## Planning Board Meeting Minutes July 7, 2022

Chairman **Dan DeLucia opened the Special Meeting at 7:00** p.m., for the purpose of Consideration of the amended application of RPNY Solar 4, LLC, requesting a zone change from Residential R-A1 to PDD (Planned Development District) for the development of an approximately 13 acre, 3 MW Community Solar Project located on tax parcel #005.-10-01.0., 5986 Clemons Road

**Re: RPNY Solar 4, LLC Planned Development District (PDD) Application  
Response to Village Board & Planning Board Comments – Glare Study & Public Safety  
File No. 331.014**

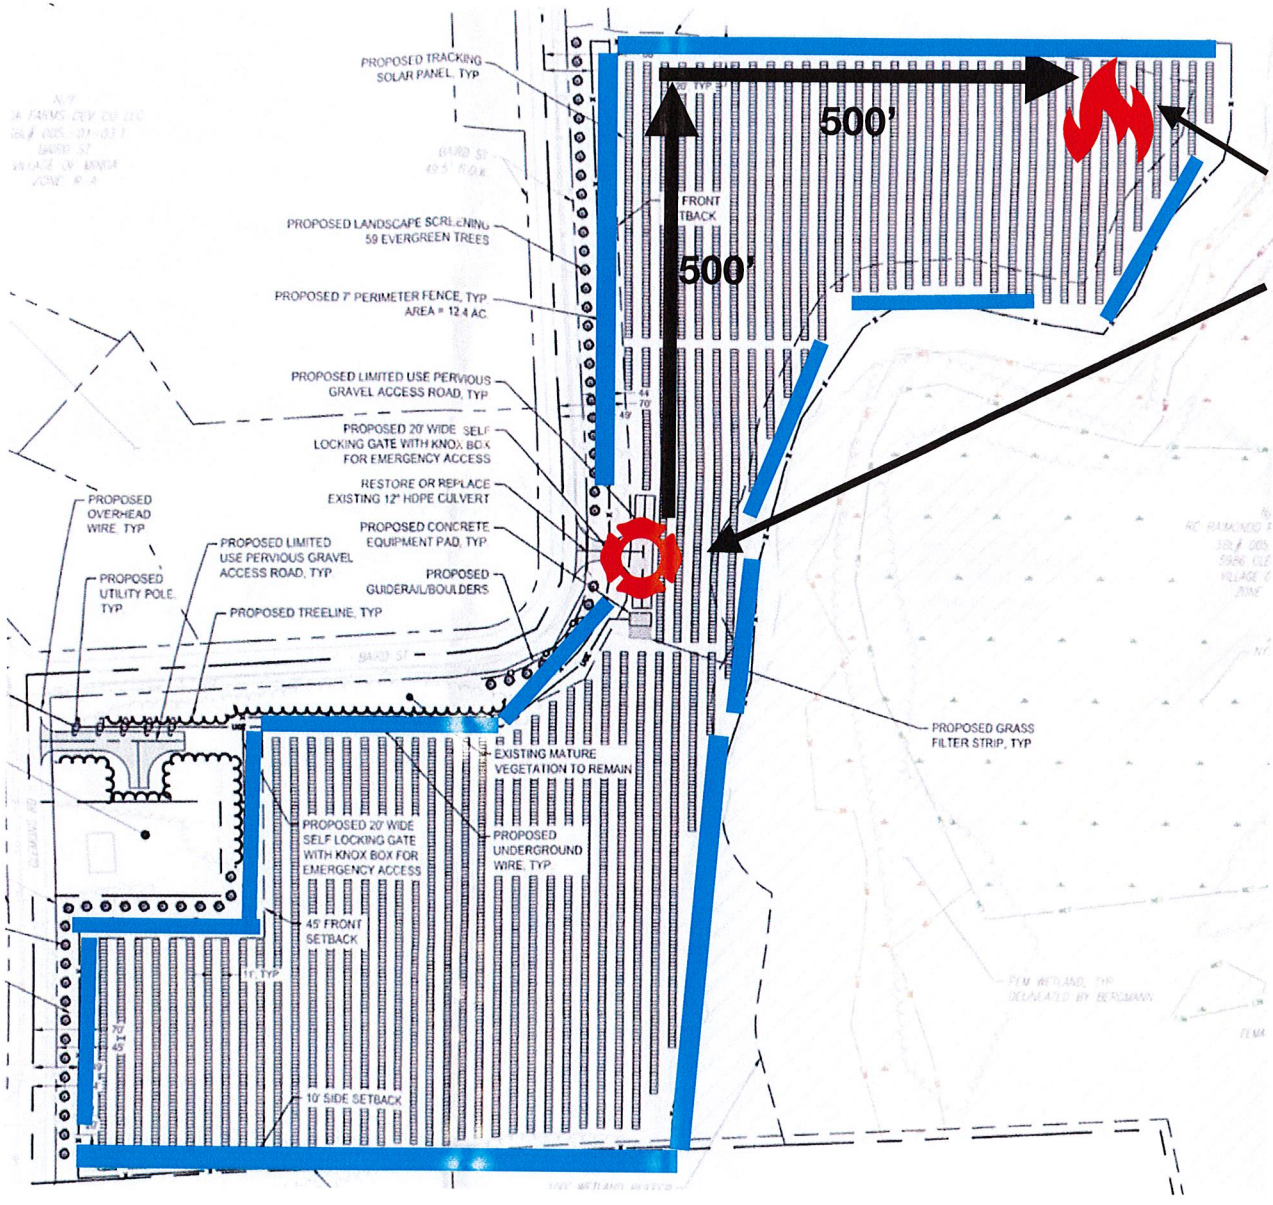
- It's difficult to tell from the drawings if fire apparatus will have drivable access 360 degrees around the solar farm. I see 2 points of initial entry to the area but am unable to tell if this continues. If not, it appears that the longest hose stretch of about 700' would far surpass our capabilities. Although this may be a rare occurrence, I must be able to control or extinguish any potential fire or rescue a person in distress in that area.
- As requested, there appears to be a guardrail at the 90 degree turn on Baird Street. This would satisfy my desire to protect cars from driving into the solar farm due to weather or unsafe speeds.
- Lastly, I understand the 7' fence code. I must however express my concern of people easily climbing this fence and accessing the solar field. Are there any other provisions for security to prevent this?

If the fire happens to be here and the closest apparatus staging location is here, this 1000' stretch is near impossible.

Is the blue area at all drivable even by pick up truck?

*"The Project will provide a 20-foot-wide unimproved access between the edge of the panels and the perimeter fence. There is little flammable material in the equipment of a solar facility, but as with any electrical system there is some risk of a fire. No special equipment is required to respond to a fire incident at a solar pv energy generating facility. The*

*recommended response to a fire is to open electrical disconnect switches and allow the fire to burn itself out. If needed, water may be used to put out any brush or grass fire.*

*In terms of fencing, Renewable Properties typically installs 6-foot tall chain link fence with 1-foot of barbed wire on top. However, due to our location within an Agricultural District, we opted for the "agricultural style" fencing without barbed wire. Should the Village wish, we are amenable to switching the fencing style to chain link with barbed wire on top."*
